Subject: Saxton Nuclear Experimental Corporation  
Operating License No. DPR-4  
Docket 50-146  
Response to Additional Comments on SNEC Final Status Survey Reports

**Survey Report OL13 Open Land**

**Survey Report SSGS Discharge Tunnel**

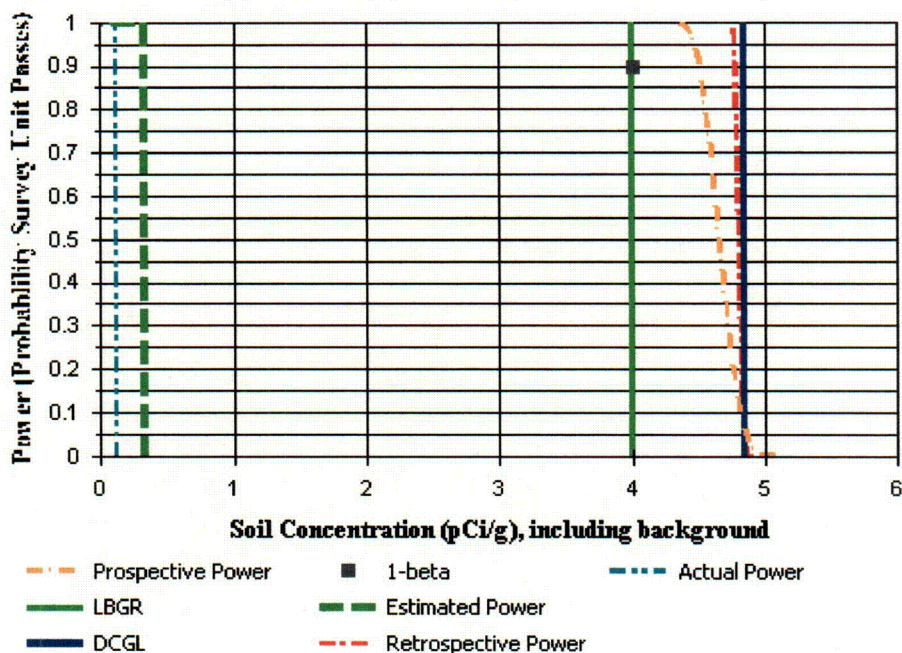
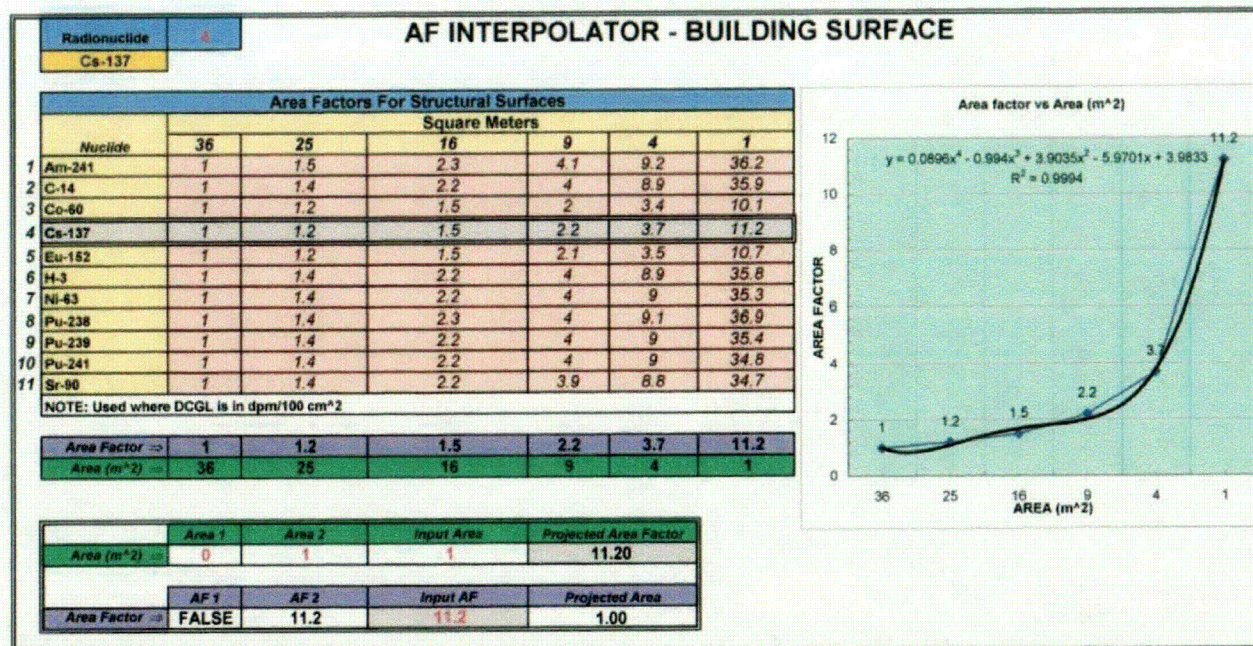
- 2) A page was missing from the appendix. The two pages of the COMPASS soil report for OL13-3 are provided below to replace the first page and provide the missing page of Appendix D.
